# Access Compliance Report

## Public Rights-of-Way

### (Curb Ramps)

Intersection ID: 27451	Main Street: PROVIDENCE_RD	Cross Street: ALLISON_WOODS_DR	Location: SE
ADA ID: 15093931C6EF	Ramp Type: Perp	Initial Pass/Fail: Fail	Overall Compliance: No
		Severity Score: 22.5

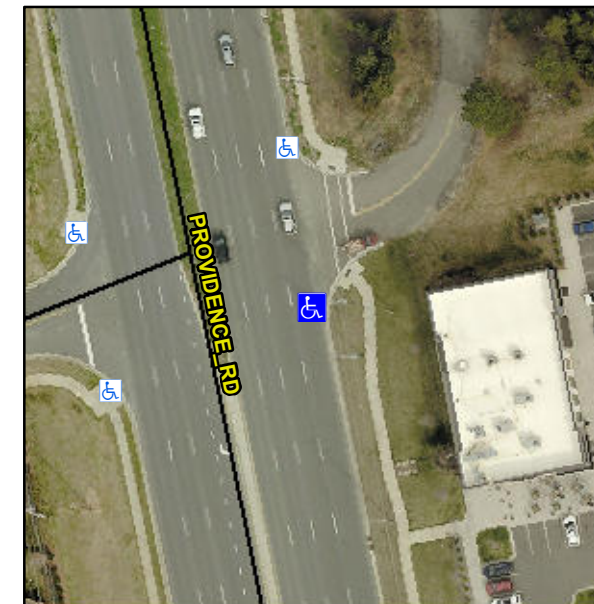
**Not Found, R304.5.1, R304.2.2**

Compliance	Description	Data	Compliance	Description	Data
N/A	Ramp Length (in)	71.0	No	Ramp Slope (%)	8.5
No	Ramp Width (in)	46.5	Yes	Ramp XSlope (%)	2.4
N/A	Flare Type LT	N/A	N/A	Flare Type RT	N/A
N/A	Flare Slope LT (%)	N/A	N/A	Flare Slope RT (%)	N/A
N/A	Flare Traversable LT?	N/A	N/A	Flare Traversable RT?	N/A
N/A	Landing Length (in)	N/A	N/A	DWS Provided?	N/A
N/A	Landing Width (in)	N/A	N/A	DWS Contrast?	N/A
N/A	Landing Slope (%)	N/A	N/A	DWS Length (in)	N/A
N/A	Landing X Slope (%)	N/A	N/A	DWS Full Width?	N/A
N/A	Landing Curb? (Y/N)	N/A	N/A	DWS Offset (in)	N/A
N/A	Shared Landing?	N/A			
N/A	Gutter Ponding?	N/A	N/A	Gutter Slope (%)	N/A
N/A	Gutter Lip Ht (in)	N/A	N/A	Gutter X Slope (%)	N/A
N/A	Painted X Walk1?	Yes	N/A	Painted X Walk2?	N/A
	X Walk 1 Direction	To N		X Walk 2 Direction	N/A
N/A	X Walk 1 Width (in)	75.0	N/A	X Walk 2 Width (in)	N/A
	X Walk 1 Slope (%)	0.7		X Walk 2 Slope (%)	N/A
	X Walk 1 X Slope (%)	2.5		X Walk 2 X Slope (%)	N/A

**Remove & Replace Entire Ramp.**
